Replacement of the Valve Cover HH (Hex Head) Collar Screws on 2004 Racing Four Stroke models

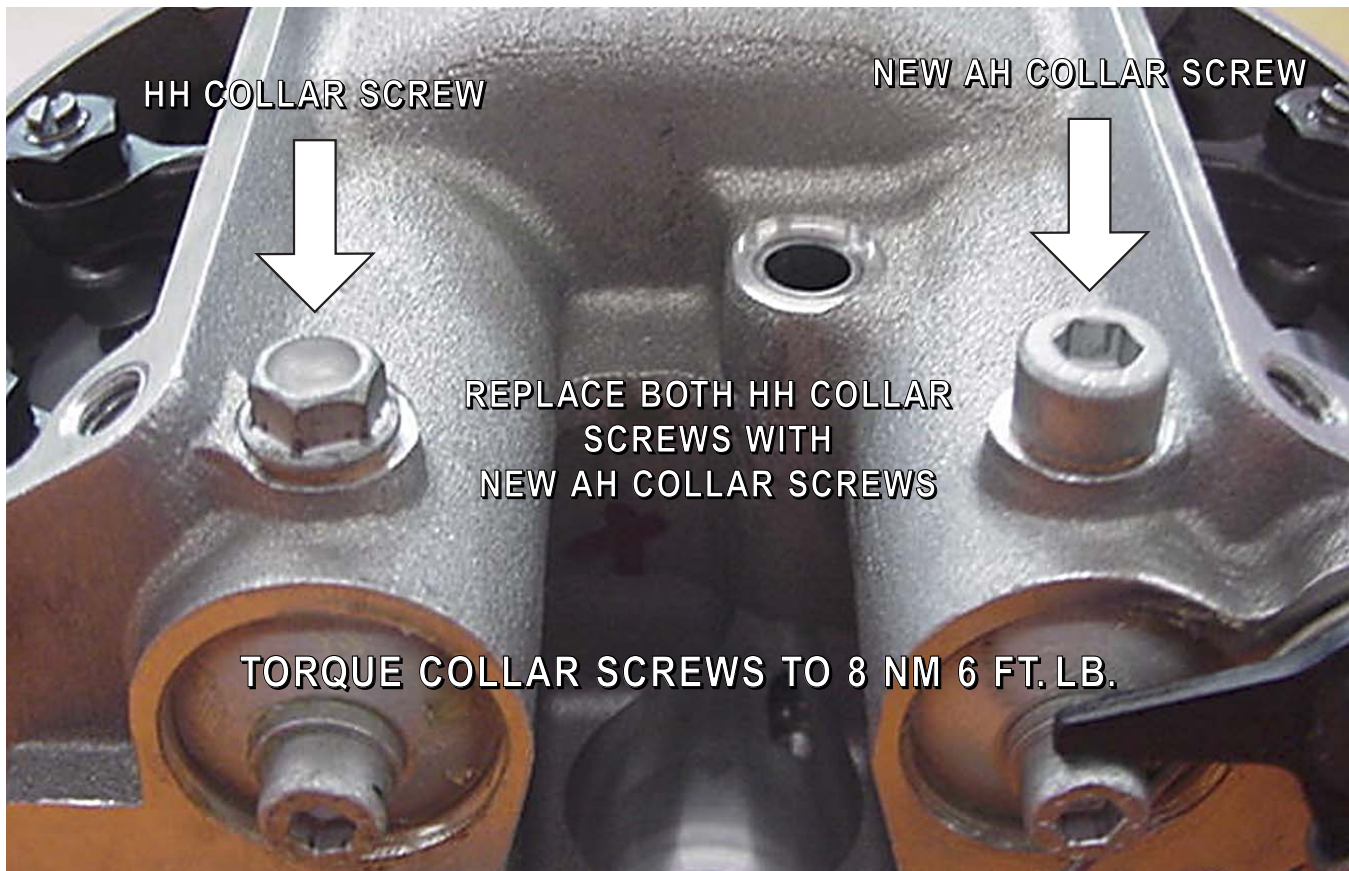
- » **During the course of regularly scheduled maintenance** it is recommended to replace the originally equipped valve cover HH (Hex Head) collar screws that were installed on some 2004 Racing Four Stroke models.

- » **Replace** the original HH collar screws with two AH (Allen Head) collar screws **M6 x 55 (Part # 0912060551)** and two new copper seal washers (**Part # 0603061001**). Only replace the two HH collar screws located above the rocker arm shaft end caps. When replacing the collar screws, it is also recommended to set the rocker arm axial play according to the Service Manual. REF: TB0041.

- » **Note:** All Racing Four Stroke models may use the new AH collar screws when replacing worn or damaged HH collar screws. The HH collar screw (**Part # 0912060553**) will be superseded with the new AH collar screw part number listed above.

- » **2004 Racing Four Stroke models**, starting with VIN: VBKRCA4024M371530 and later, have been fitted with the new AH collar screws during production.
